**USC CP00367346 DM12 USC A - Penland and H&SS Building Fire Alarm Upgrades**

ADDENDUM NO. 2  
February 27, 2015

PROJECT NUMBER: C13047  
 REFERENCE DWG: E201  
 RFI/ADD./COR: ADD NO. 2  
**E101.1**  
 DATE: 27 FEBRUARY 2015

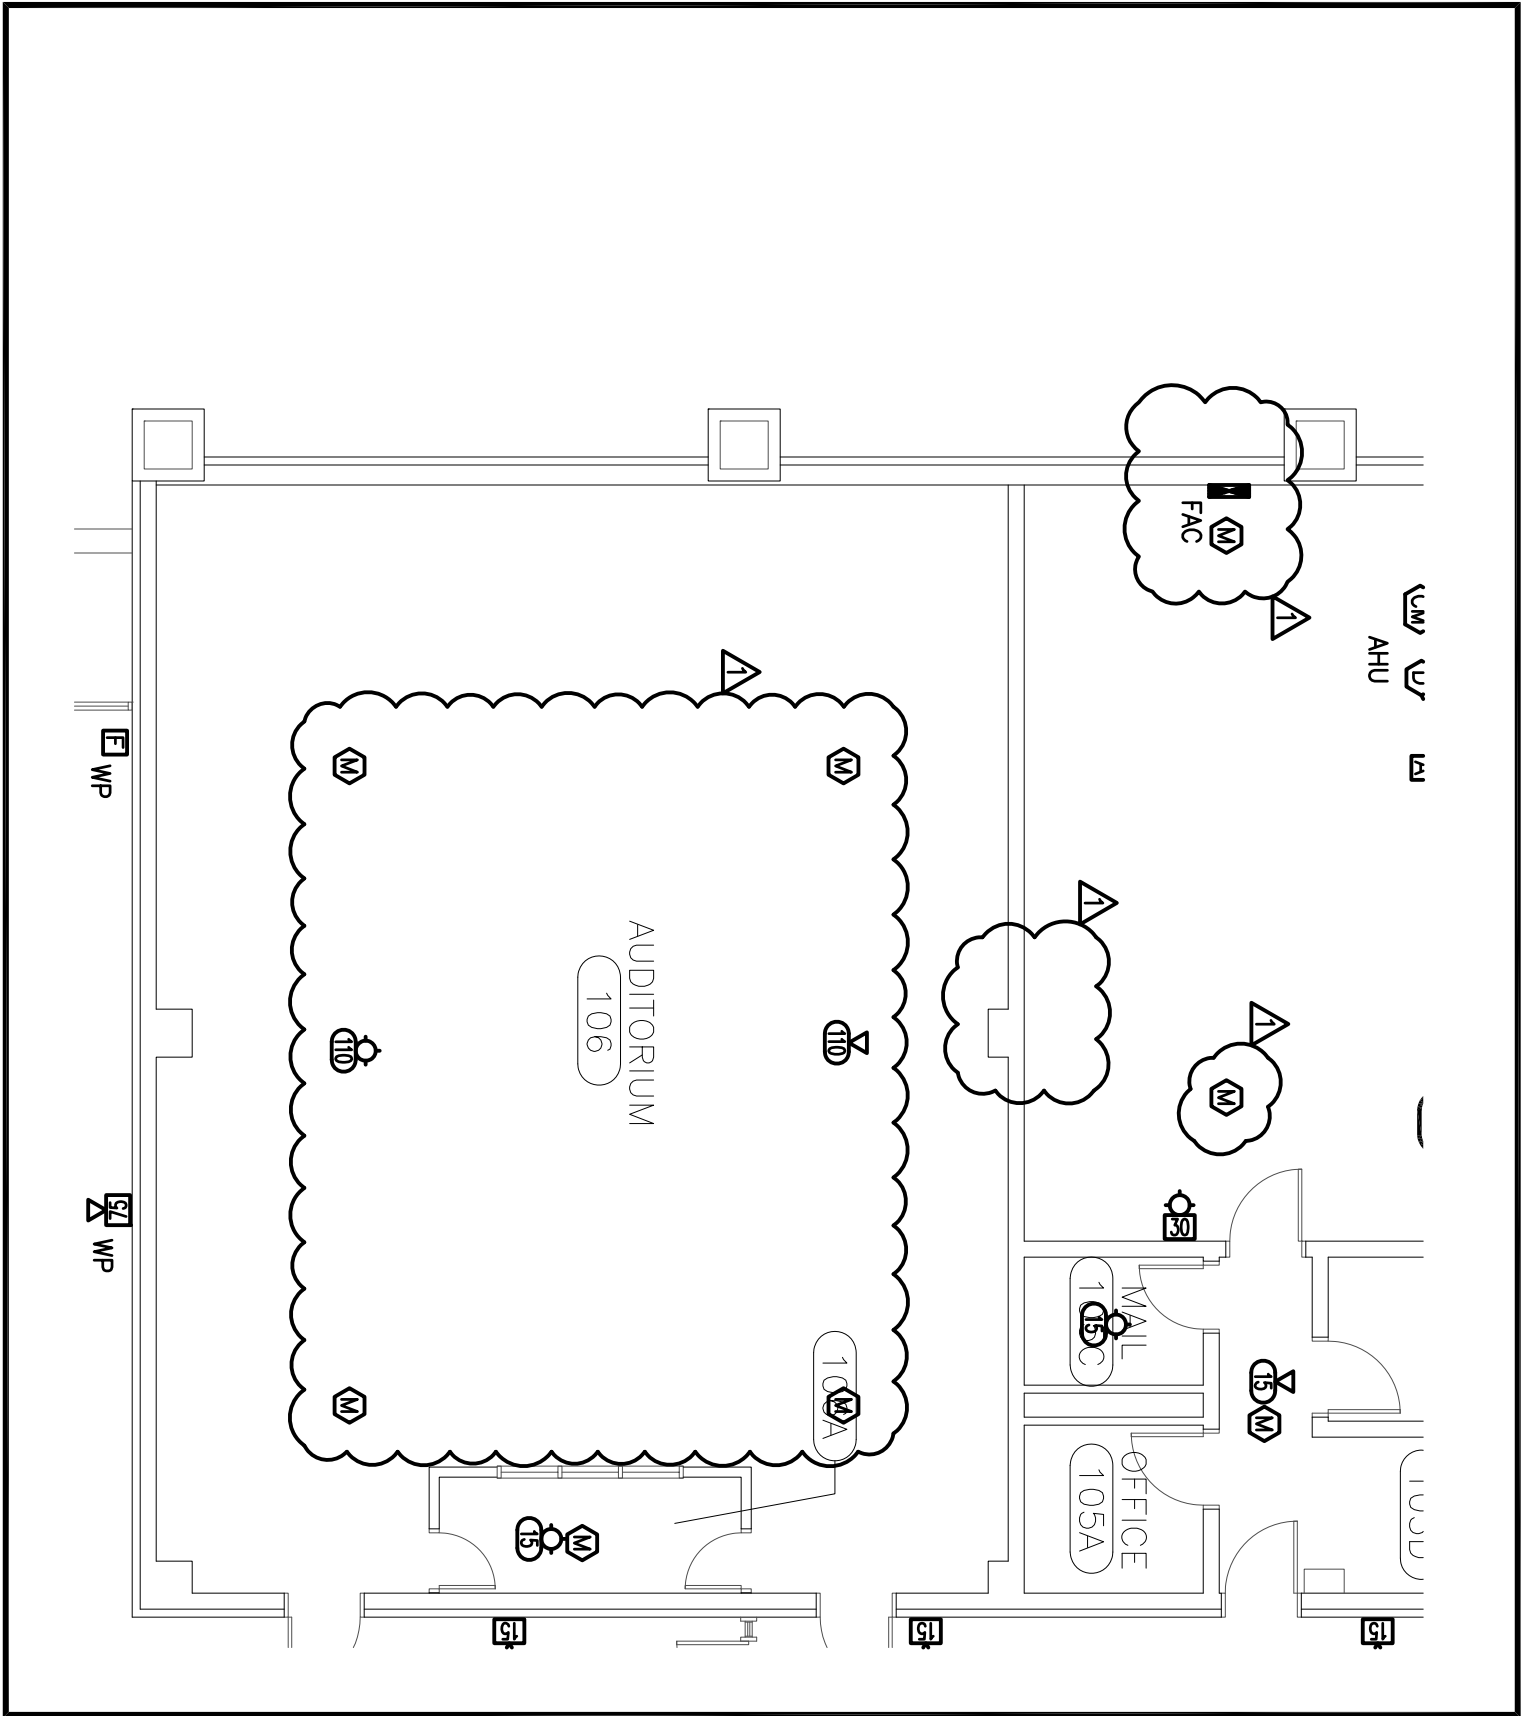
- a. E001: General Notes No. 1 – Replace text “2008 NATIONAL ELECTRICAL CODE” with “2011 NATIONAL ELECTRICAL CODE”.
- b. E101(Penland):  
E101.1 (See attachment) – Change approximate location of fire alarm control panel and add one multi-detector in Mech/Elec room, add two ceiling mounted multi-detectors and one ceiling mounted strobe to Auditorium 106 located above aisles.
- c. E201(H&SS):  
E201.1 (See attachment) – Remove two beam type smoke detectors and add three ceiling mounted multi-detector in Auditorium 116 located above aisles.  
E201.2 (See attachment) – Remove two beam type smoke detectors and add three ceiling mounted multi-detector in Classroom 103 located above aisles.  
E201.3 (See attachment) – Change approximate location of fire alarm control panel in Elec. E-3.
